# Access Compliance Report

## Public Rights-of-Way

### (Curb Ramps)

Intersection ID: 12046	Main Street: S_CEDAR_ST	Cross Street: W_1ST_ST	Location:	N
ADA ID: 0A9CD41066DF	Ramp Type: Directional2	Initial Pass/Fail: Fail	Overall Compliance: No	Severity Score: 25

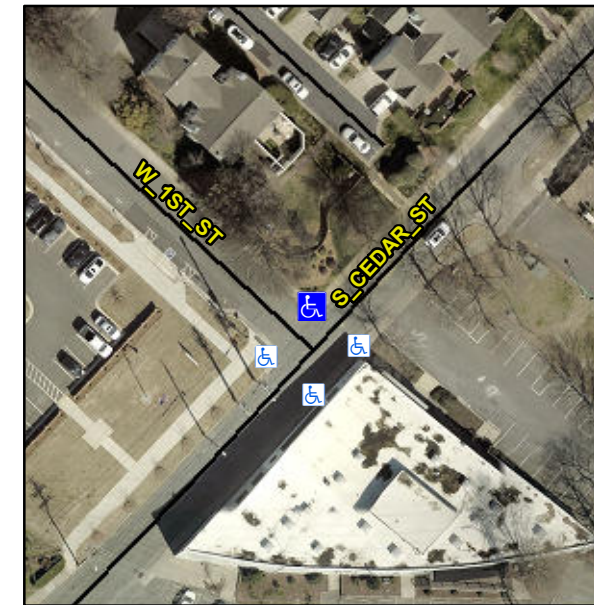
**R304.2.2**

**Remove & Replace Entire Ramp.**
